Access Compliance Report

Public Rights-of-Way

(Curb Ramps)

Intersection ID: 49150	Main Street: VIDAL_LN	Cross Street: DACAVIN_DR	Location: W
ADA ID: 3088A05BFB4E	Ramp Type: PerpDiag	Initial Pass/Fail: Fail	Overall Compliance: No
Severity Score: 33.75			
Codes/Mitigation Info/Possible Solution		Field Measurements/Component Compliance

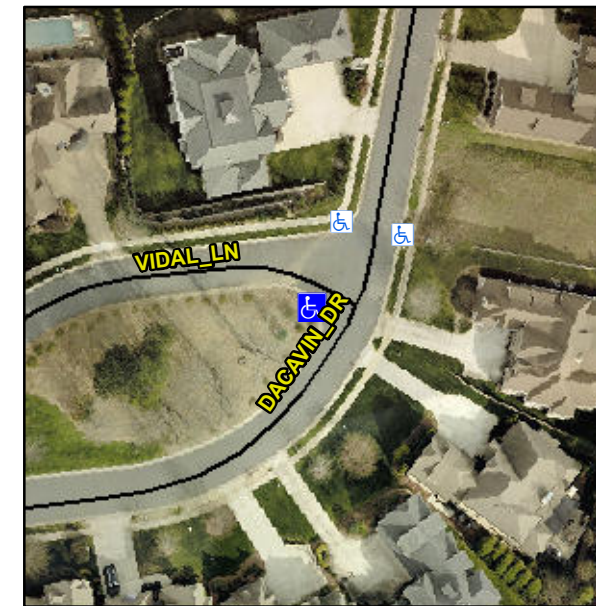
Not Found, R304.5.1, R304.5.3

Compliance	Description	Data	Compliance	Description	Data
N/A	Ramp Length (in)	48.0	Yes	Ramp Slope (%)	5.3
No	Ramp Width (in)	45.0	No	Ramp XSlope (%)	14.9
N/A	Flare Type LT	N/A	N/A	Flare Type RT	N/A
N/A	Flare Slope LT (%)	N/A	N/A	Flare Slope RT (%)	N/A
N/A	Flare Traversable LT?	N/A	N/A	Flare Traversable RT?	N/A
N/A	Landing Length (in)	N/A	N/A	DWS Provided?	N/A
N/A	Landing Width (in)	N/A	N/A	DWS Contrast?	N/A
N/A	Landing Slope (%)	N/A	N/A	DWS Length (in)	N/A
N/A	Landing X Slope (%)	N/A	N/A	DWS Full Width?	N/A
N/A	Landing Curb? (Y/N)	N/A	N/A	DWS Offset (in)	N/A
N/A	Shared Landing?	N/A			
N/A	Gutter Ponding?	N/A	N/A	Gutter Slope (%)	N/A
N/A	Gutter Lip Ht (in)	N/A	N/A	Gutter X Slope (%)	N/A
N/A	Painted X Walk1?	No	N/A	Painted X Walk2?	No
	X Walk 1 Direction	To E		X Walk 2 Direction	To NE
N/A	X Walk 1 Width (in)	N/A	N/A	X Walk 2 Width (in)	N/A
	X Walk 1 Slope (%)	3.9		X Walk 2 Slope (%)	13.2
	X Walk 1 X Slope (%)	16.3		X Walk 2 X Slope (%)	4.8

Remove & Replace Curb Ramp With Two New Directional Ramps or Equivalent.
